Rezoning Transportation Analysis

Petition Number: 2022-187 General Location Identifier: 19356102

Date	Description		
3-22-23	First Review (IW)

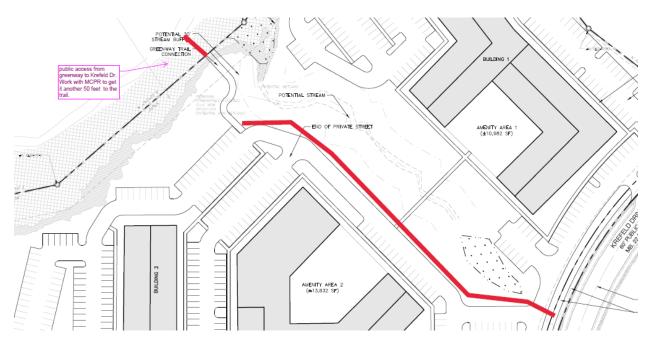
3. Revise site plan and conditional note(s) to commit to dedicate 40' of right-of-way from the road centerline. The site plan shall label and dimension the right-of-way from the road centerline.

Revise site plan and conditional note(s) to commit to construct bicycle facilities by locating the curb and gutter 24' from the center line to meet the Council-adopted Charlotte BIKES Policy and to support Council-adopted Charlotte Streets map.
